ITEM 5. DEVELOPMENT APPLICATION: 128-150 ROSS STREET FOREST LODGE - FORMER HAROLD PARK PACEWAY**FILE NO: D/2014/653****DEVELOPMENT APPLICATION NO: D/2014/653****SUMMARY****Date of Submission:** 13 May 2014. Amended plans received on 24 September 2014.**Applicant:** Mirvac Projects Pty Ltd**Architect:** Mirvac Design, Smart Design Studio**Developer:** Mirvac**Owner:** Mirvac Projects Pty Ltd**Cost of Works:** \$75,490,297**Proposal Summary:** The proposal seeks approval for a Stage 2 application for Precinct 4 at the former Harold Park paceway site, comprising construction of 2 residential flat buildings (3-8 storeys) containing 160 residential apartments, basement parking for 144 cars, a green roof on each building and associated landscaping.

Figure 12: Proposed envelope section

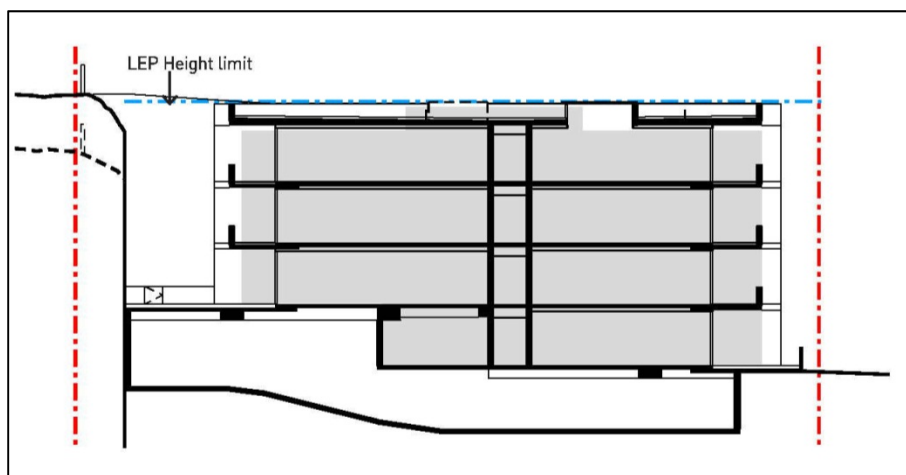
56. The application proposes a non-compliance with the Stage 1 approved height in storeys, which specifies a maximum of three storeys for Building 4A. The proposal provides for a three storey form fronting the adjoining eastern cliff with a four storey form to the public park to the west (Figure 13).

57. As a result of the level changes across the site, the additional storey is able to be accommodated within the LEP height control. Views across the site when viewed from Maxwell Road and the surrounding Glebe neighbourhood are also maintained. The additional storey does not result in significant non-compliances with the approved Stage 1 envelope height. Further, due to the location of the site below the cliff line, the additional storey will not result in additional overshadowing or privacy impacts to adjoining properties or open space.
58. In light of the above, the height in storeys non-compliance is considered acceptable.

Figure 14: Originally proposed elevation to Maxwell Road. Red line shows the cliff line.

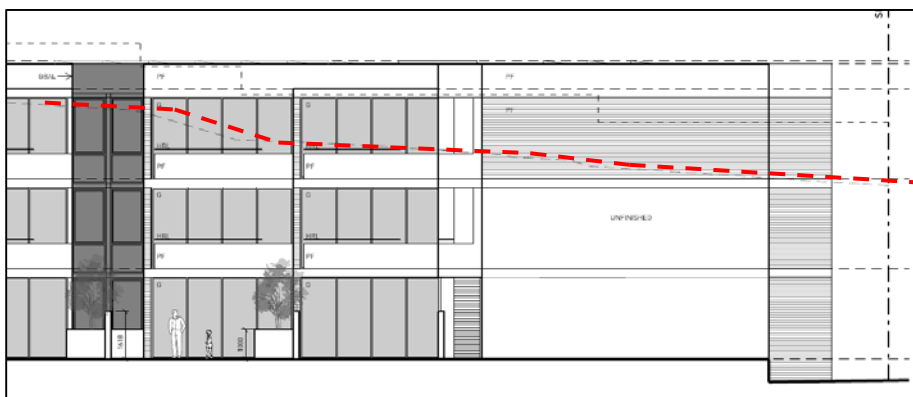
66. In addition to the above setback departures, the proposal also includes an extension of the approved building envelope to meet the cliff face at the north-eastern corner of the building.
67. The original proposal included a primary pedestrian building entrance via MC06, with no formal access point or street address to Maxwell Road. The proposed arrangement presented significant issues for the legibility of the building for visitors, deliveries and mail.
68. In addition to the legibility issue of not providing a street address, the original proposal included a blank wall to the portion of the Maxwell Street elevation that is visible above the cliff line (Figure 15).

69. The light of the above, the applicant was requested to amend the design of the building to include a building entrance, including security door and mailboxes with direct access for all apartments within the building.
70. The proposal has been modified to include a secure access point which will be utilised by residents of the building and their visitors. Public access to the Harold Park site through this entry will not be permitted.
71. The inclusion of a building entry and street address will improve the legibility and appearance of the building, activate the street and provide for appropriate casual surveillance of the neighbourhood. On balance, the non-compliance with the approved building envelope is considered to be acceptable.
